## Section 75W Modification

### Commercial Building C3 - MP11\_0044 (Mod 2)

Barangaroo South

Submitted to Department of Planning and Infrastructure  
On Behalf of Lend Lease (Millers Point) Pty Ltd

**Figure 2** – Approved (PPR) and proposed (Section 75W) podium design

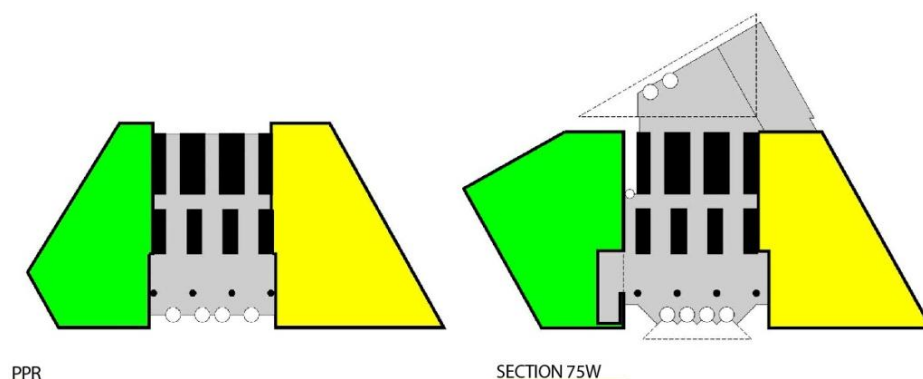
Consistent with the design development and the realignment of blocks and streets currently proposed via Concept Plan (Mod 6), the general podium design and siting is proposed to be modified (refer to **Figure 2**). An overall increase to podium area is sought, with the podium generally extending further north east and the addition of a northern element in the form of a lobby. These refinements are intended to better achieve consistency with Concept Plan Urban Design Controls 5 and 8 relating to ground floor permeability, accessibility to the public realm and active street fronts.

The predominant height of the podium is not proposed to be amended, apart from minor increases in height to account for plant enclosures. Overall, these changes will strengthen the identity, building and human scale of Commercial Building C3.

Level	Design Change
<b>Ground</b>	<ul style="list-style-type: none"> <li>▪ A new north lobby entry from future Globe Street.</li> <li>▪ Recessed north lobby facade.</li> <li>▪ Provide a setback to the south lobby from the podium facades.</li> <li>▪ New (internal) through-site link within podium lobby space.</li> <li>▪ Reconfigured retail spaces.</li> <li>▪ Reconfigured fire stairs, plant and amenities.</li> <li>▪ Reconfigured and increased podium floor plate design.</li> <li>▪ Relocation and rationalisation of the basement vehicle ramp.</li> </ul>
<b>Level 1</b>	<ul style="list-style-type: none"> <li>▪ Reconfiguration of plant and amenities.</li> <li>▪ Reconfigured and increased podium floor plate design.</li> <li>▪ Increase in lobby void.</li> <li>▪ Inclusion of outdoor terrace.</li> <li>▪ Relocation of child care floor space from podium level 3.</li> </ul>
<b>Level 2</b>	<ul style="list-style-type: none"> <li>▪ New pedestrian bridge over internal void.</li> <li>▪ Reconfiguration of plant and amenities.</li> <li>▪ Reconfigured podium floor plate design.</li> <li>▪ Increase in lobby void.</li> </ul>

<b>Level 3</b>	<ul style="list-style-type: none"> <li>▪ Replace childcare use (relocated to Level 1) with office use.</li> <li>▪ Removal of commercial annex and replacement with terrace.</li> <li>▪ Provision of new roof structures over the north and south lobby spaces.</li> <li>▪ Provision of additional plant.</li> <li>▪ Reconfigured and increased podium floor plate design.</li> </ul>
<b>Level 4</b>	<ul style="list-style-type: none"> <li>▪ Reconfiguration commercial floor plate.</li> <li>▪ Infill of balconies with commercial floor space.</li> <li>▪ Relocated plant room.</li> </ul>
<b>Level 5</b>	<ul style="list-style-type: none"> <li>▪ Reconfigured plant roof.</li> <li>▪ Infill of balconies with commercial floor space.</li> </ul>

**Figure 7** – View of the refinements to the tower facade

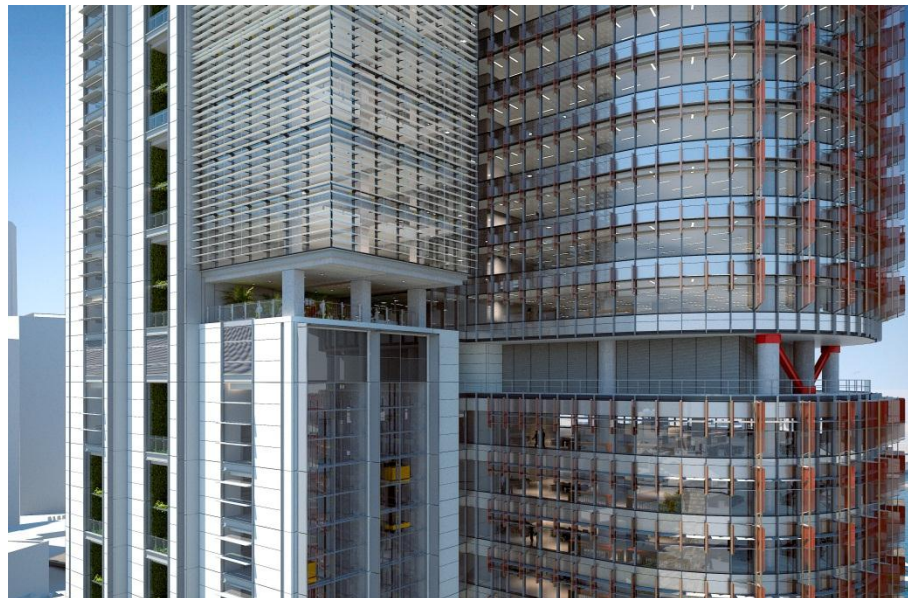
The brace systems on the mid-rise plant floors (levels 18 and 34) are to be amended from a “K-brace” to a “V-brace”. The change in configuration from a K-brace to a V-brace is required to provide improved structural stability, reduced building sway and has the benefit of reducing the size of the tower perimeter columns.

The approved concept for the floorplate solar shading elements has been refined to better express key elements of the design including the verticality and legibility of the tower. The use of ceramic frits, large vertical fins and smaller horizontal shading elements contribute to achieving verticality in the building form. A slightly refined colour scheme will highlight the different elements and enhance the overall language of the building (see **Figure 7**).

Figure 8 – Approved and modified roof form

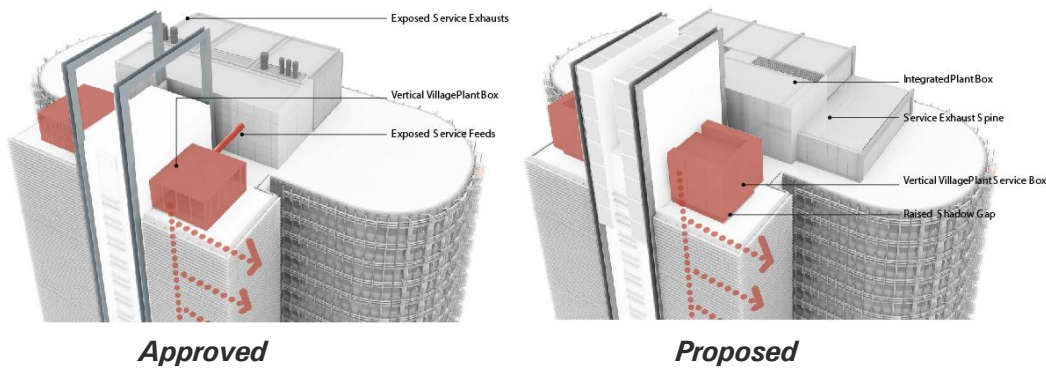
An amended roof form is proposed to provide a stronger termination point, enhancing its legibility and re-organising roof plant (see **Figure 8**).

The new plant enclosures above the vertical villages are necessary to service the vertical villages and create a stronger termination of the north core. The main roof plant has been organised into a system of bays with structural framing. A double storey core plant box is proposed which will integrate the exhaust in the plant box. The alignment of this integrated upper plant box serves to accentuate the served and servant relationship of north and south cores, whilst adding to the sibling relationship across all 3 towers. Louvred end bays reflect the form of the plant box as distinct to the profile of the tenant floors below.

Figure 9 – Approved and modified tower signage zone locations

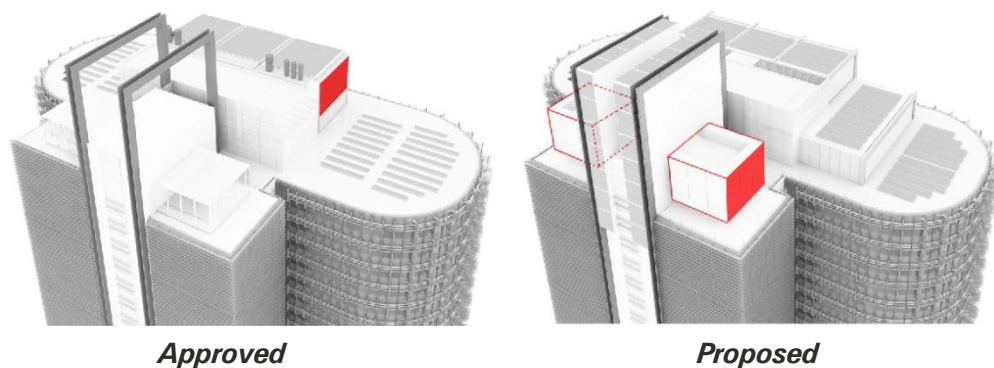
The increased size of the plant enclosures for the vertical villages and reconfiguration of the roof top plant provides for new opportunities for building signage (see Figure 9). The alternative locations provide an appropriate zone for the future building identification signage and assists with the articulation of the service elements of the tower and screening of necessary plant. The previous approved signage zones on the tower plant room have been removed. Slight amendments have been made to the podium signage zones to account for the amended podium design.

The location and size of these podium signage zones is generally consistent with the currently approved zones.
